FREDERICK COUNTY PLANNING COMMISSION

TITLE: Conservation Hill, Section 2, Lots 202-205

FILE NUMBER: M-2895, AP 14683 (APFO N/A, FRO 14684-14687)

REQUEST: **Agricultural Cluster Concept Plan Approval**
The Applicant is requesting Concept Plan approval for a 4-lot Agricultural Cluster subdivision on a 192.58-acre property.

Concept Plan Layout

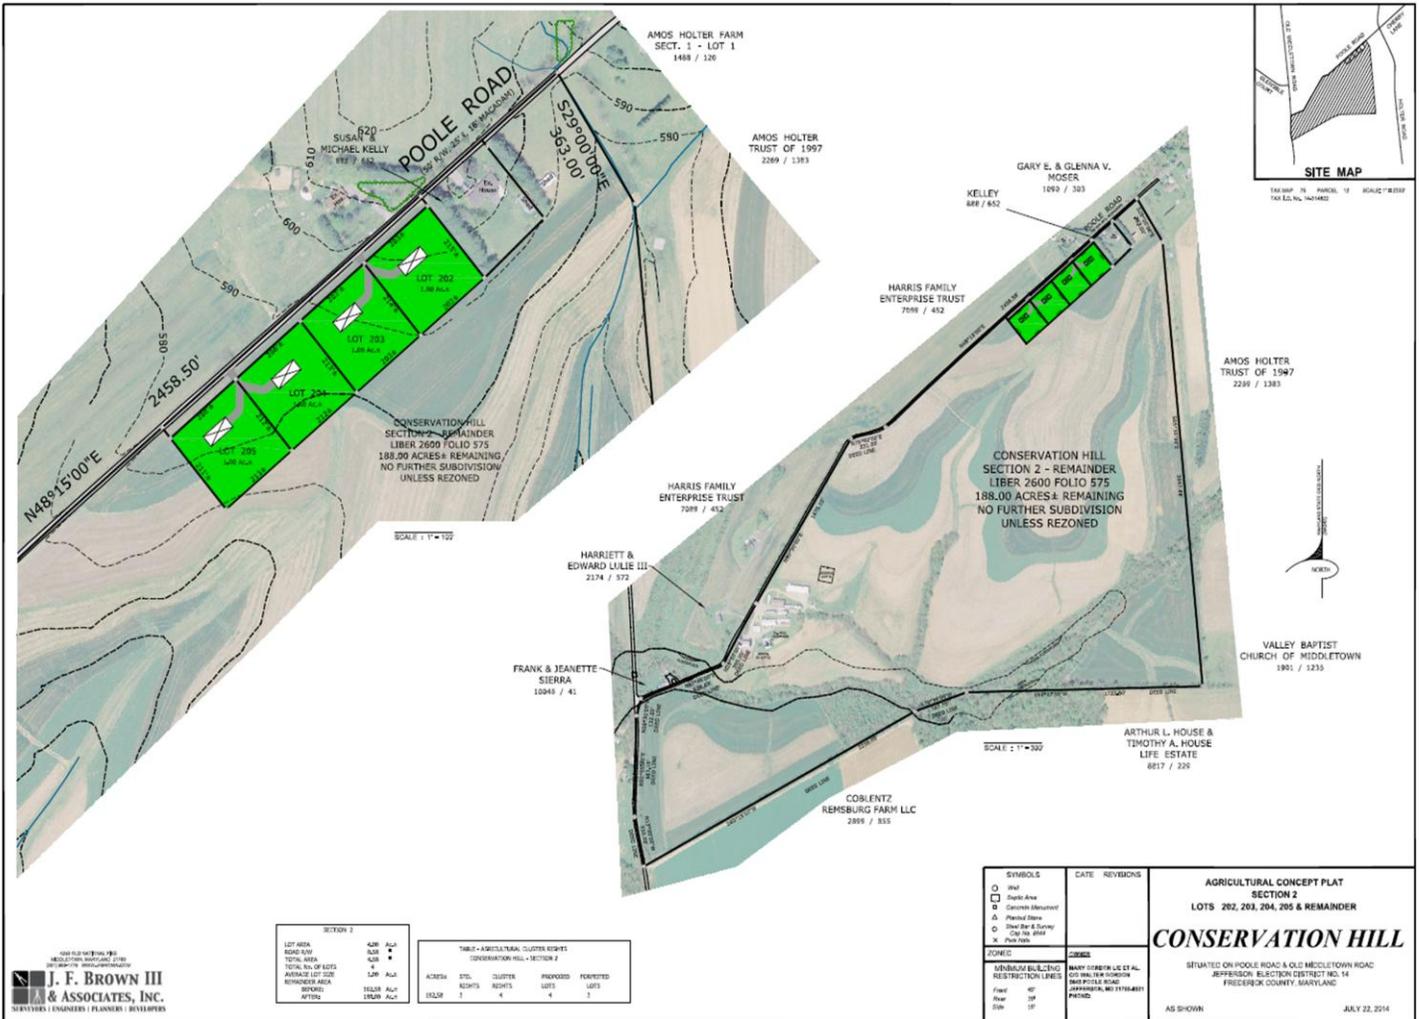
The proposed four-lot subdivision is situated in the northwest corner of the property, adjacent to the existing lot that was subdivided off the farm in 1972. The site of the proposed subdivision does not contain prime agricultural soils. The proposed subdivision location is adjacent to existing residential development.

Wet soils (MmB) are located exactly 100 feet behind Lots 204 and 205. The proposed house sites are over 200 feet from the wet soils boundary. A soils delineation report is not required.

The proposed lots will access Poole Road, which is designated a local roadway on the Comprehensive Plan and has a 16 foot wide travelway. Although the existing travelway meets the criteria for a minor subdivision, the minimum right of way width of a local roadway is 50'. Therefore a right-of-way dedication is required along the frontage of the proposed lots. Lot access to Poole Road will be via two common entrances. Notes will be required on the final plat indicating that the lot owners shall be responsible for maintaining the common entrances. The common entrances must be constructed prior to lot recordation in accordance with §1-16-109(D)(8). Lot access will meet the Subdivision Regulation requirements.
